Sandia National Laboratories

January 20, 1983

We have completed our review of the document entitled "TMBDB Melting Scenario" which you forwarded to us. The document evaluates the consequences of a non-coolable core debris bed early in a TMBDB scenario. Using several simplifying assumptions, a combined TRUMP/CACECO analysis was used to define the consequences in terms of CRBR's thermal margins. It was concluded that containment conditions would be acceptable and there would be a maximum basemat penetration of about 5 feet at sodium boil-dry.

Discussion of Assumptions Made in the Melting Scenario

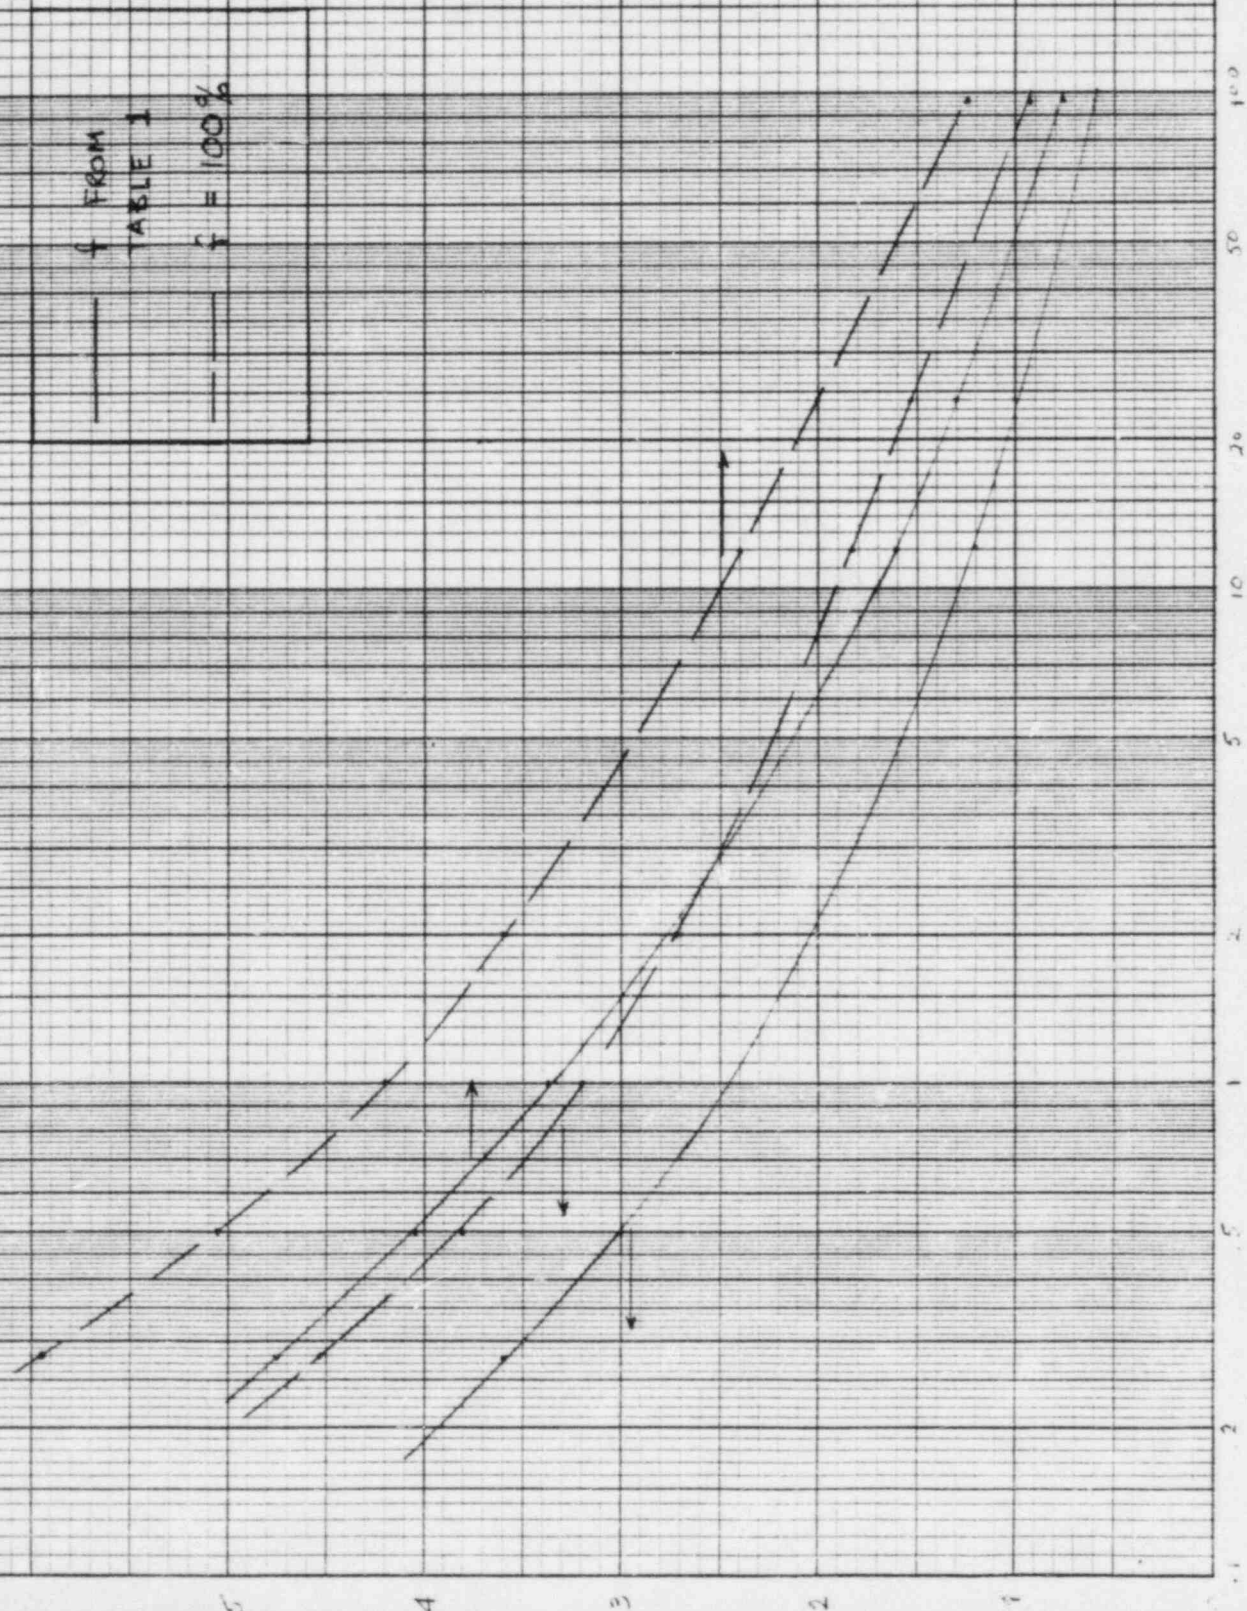
In order to compare the concrete erosion distances calculated using these equations and the TRUMP/CACECO analysis, heat fluxes and erosion velocities were calculated using the f values given in Table 1 of the TMBDB melting scenario report. These results are given in Figure 1. Graphically integrating the erosion velocity curve with respect to time, the total erosion during the initial 71 hours (the boildry time) is estimated to be about 75 cm or 2.5 feet. This is one half the value calculated using the TRUMP/CACECO analysis.

Taking into account our reservations about the conservatism of the assumptions used in the TRUMP analysis, we recalculated the heat fluxes and erosion velocities assuming that 100% of the decay heat is transferred to the concrete. These results are also shown in Figure 1. Performing a similar integration, a total erosion of 109 cm or 3.6 feet is calculated. Once again, this value is less than that calculated by the CRBRPO. Although these calculations are not as elegant as the transient TRUMP/CACECO analysis, we have used similar analyses to successfully predict concrete erosion rates in the FRAG tests. We conclude, therefore, that the methodology used in the TRUMP/CACECO analysis is conservative.
